**NOTICE AND AGENDA OF
PUBLIC MEETING**

**SPECIFICATIONS
SUBCOMMITTEE**

1:30 P.M. AUGUST 14, 2019

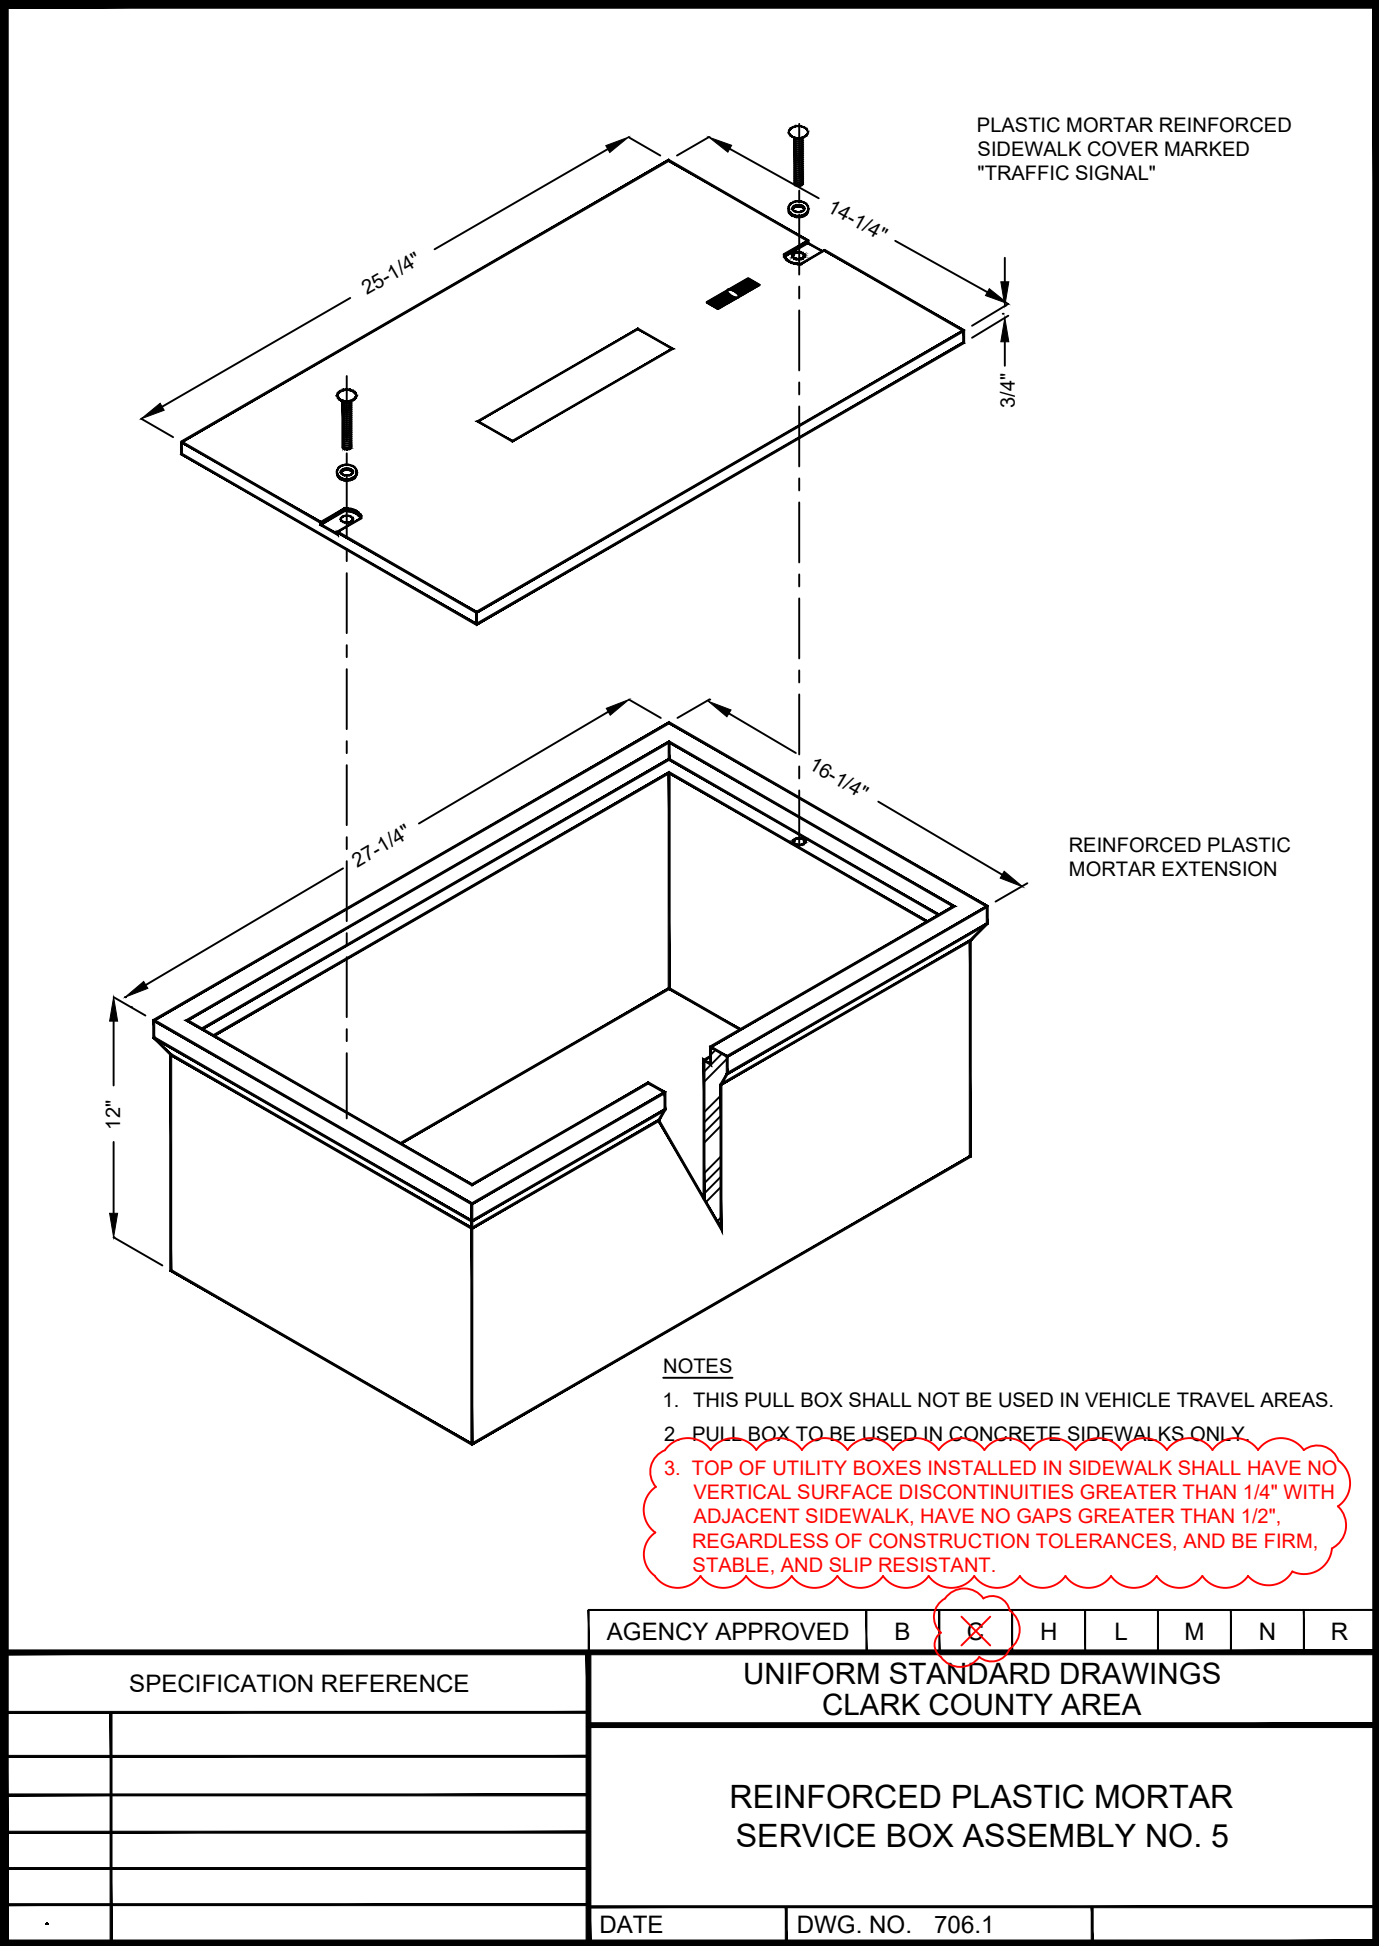
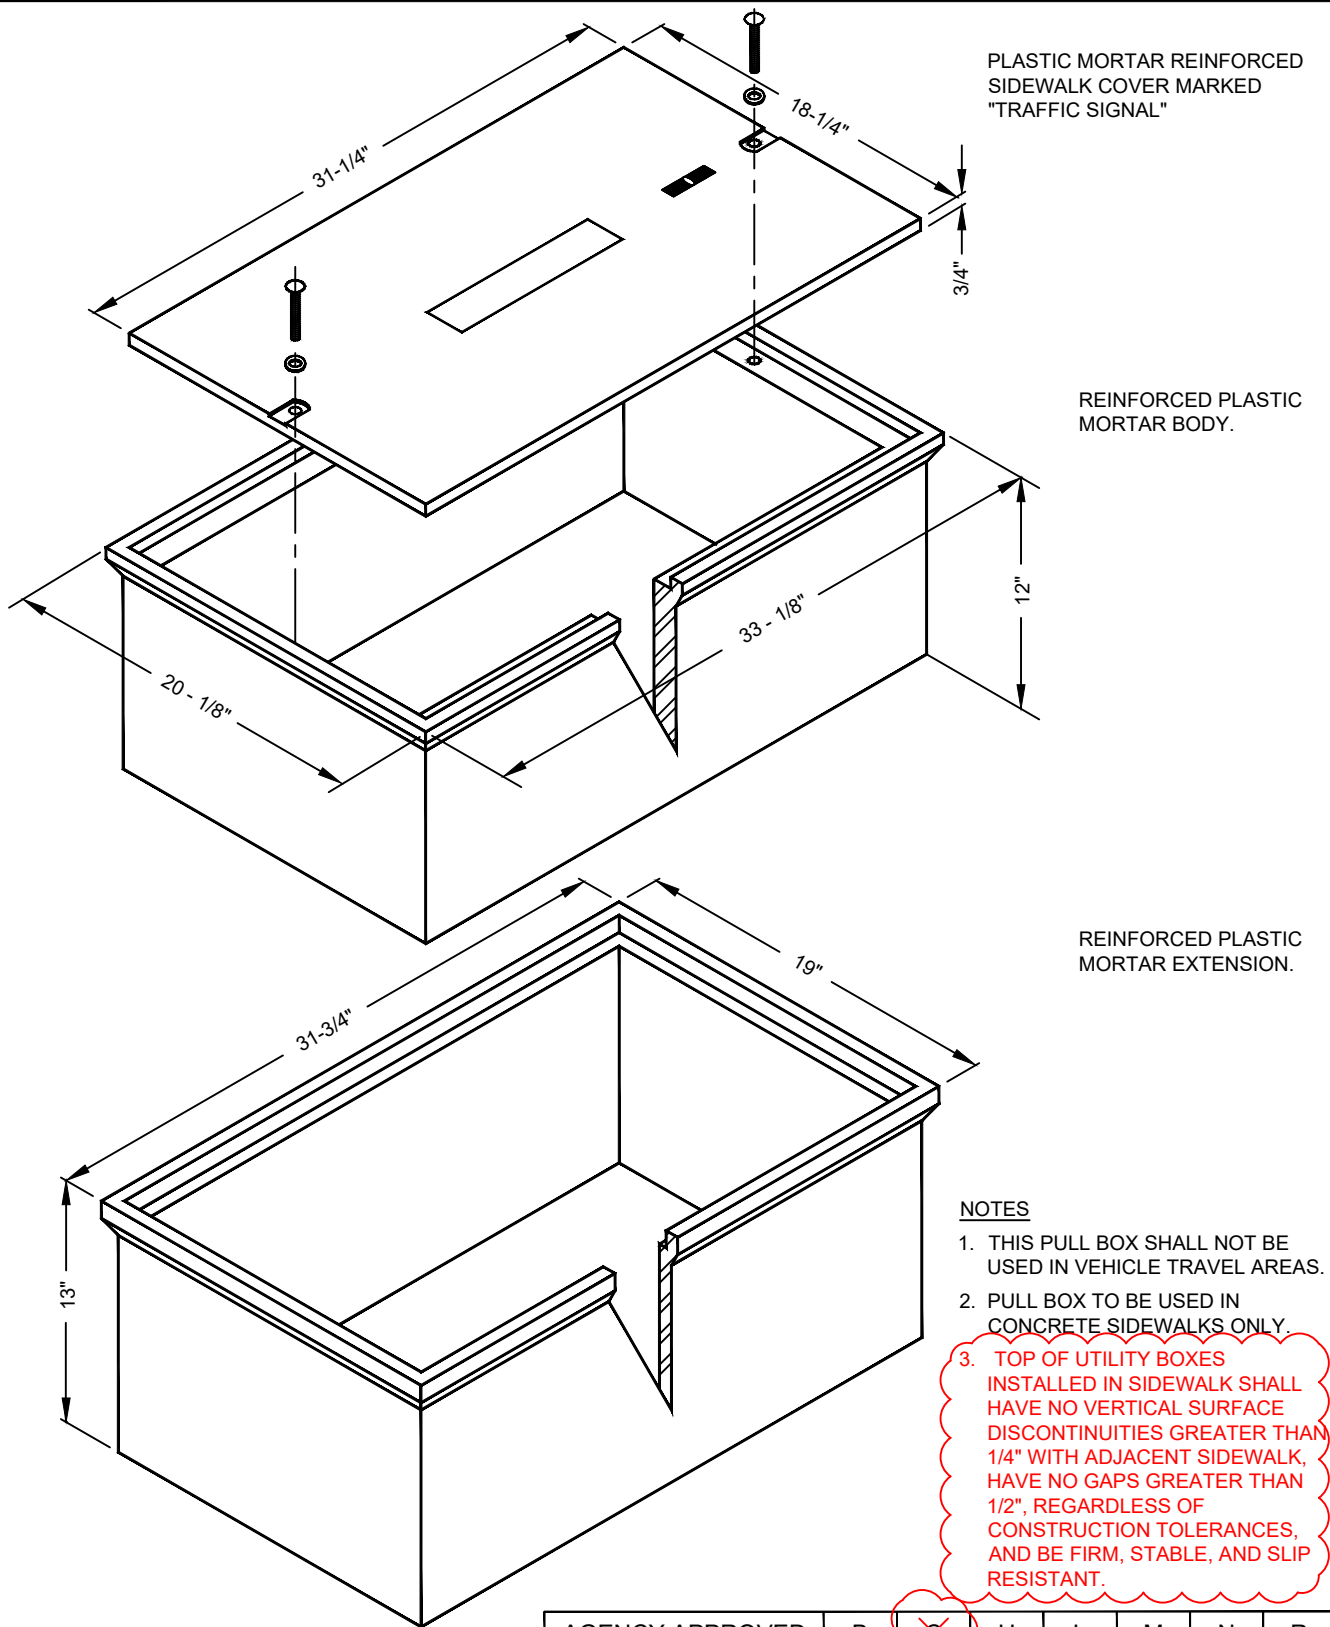
Kimley-Horn and Associates (Kimley-Horn) recently completed an audit of the regional standard drawings to determine the extent to which they reflect and adhere to current accessibility law and guidelines. The Americans with Disabilities Act (ADA) and the proposed Public Right-Of-Way Accessibility Guidelines (PROWAG) both give direction and guidance on how to provide safe and effective infrastructure for all road users regardless of physical or mental capabilities. The drawing revisions suggested by Kimley-Horn, based on the audit, were presented in the form of redlined drawings at the March 19, 2019 Operations Subcommittee (Subcommittee) meeting, and members were asked to provide comments on the suggested revisions. Following review of the comments, staff refined Kimley-Horn's redlines and prepared a set of drawings that depict the proposed revisions for the Subcommittee to consider at its July 16, 2019 meeting.

Uniform Standard Drawings 706.1 "Reinforced Plastic Mortar Service Box Assembly No. 5" and 707.1 "Reinforced Plastic Mortar Service Box Assembly No. 7" were discussed at the July 16, 2019 Operations Subcommittee meeting, and Clark County requested to be removed from the drawings. It was suggested that construction of the plastic mortar service box designs may be out of practice in the Las Vegas Valley, and Subcommittee members were asked to review the drawings to determine if the designs are still in use amongst the jurisdictions. It was determined that the drawings would be brought to the Specifications Subcommittee agenda for further discussion.

AGENCY APPROVED		B	C	X	M	N	R
SPECIFICATION REFERENCE		UNIFORM STANDARD DRAWINGS CLARK COUNTY AREA					
302	AGGREGATE BASE	RESIDENTIAL DRIVEWAY					
501	CONCRETE						
502	CONCRETE STRUCTURES						
707	JOINT MATERIAL						
DATE XX-XX-XX		DWG. NO. 223

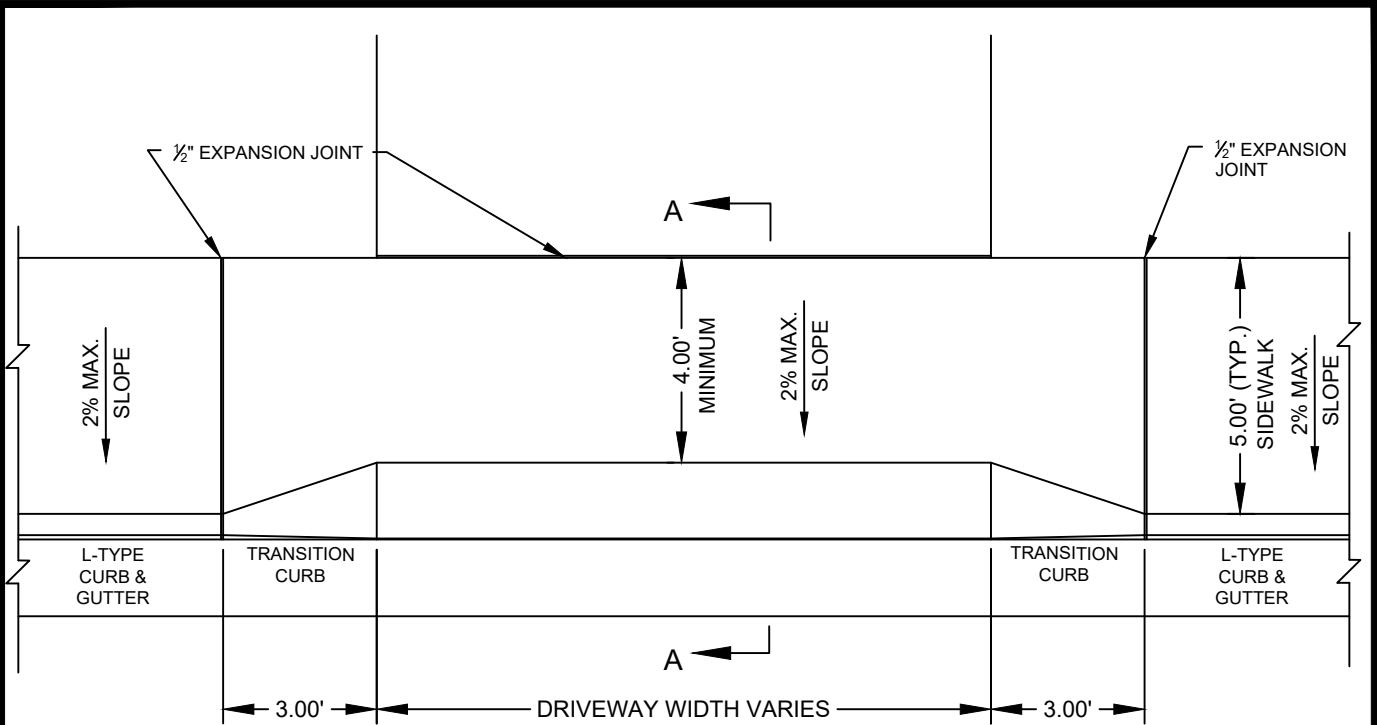
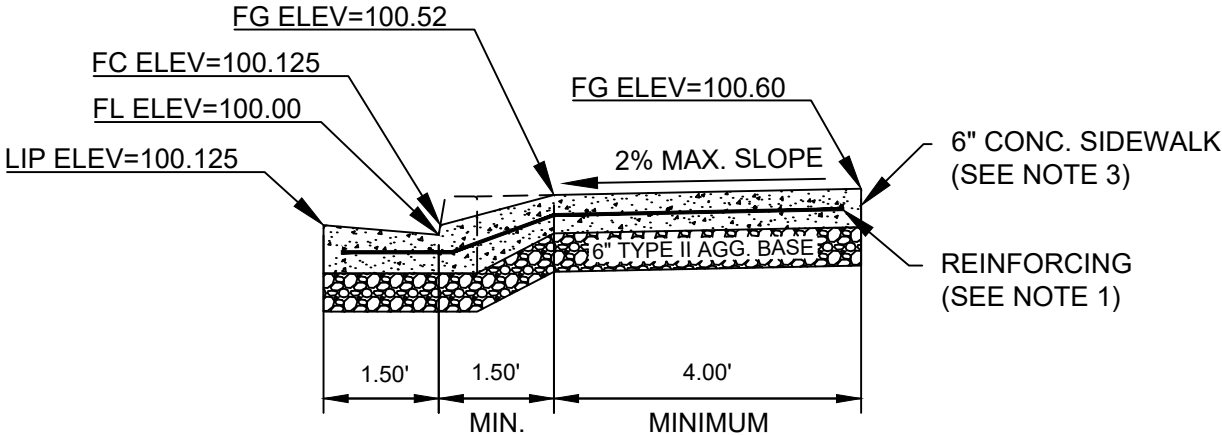
The City of Las Vegas submitted a request to be removed from Uniform Standard Drawings 223 and 224 and added to Uniform Standard Drawing 226.S1.
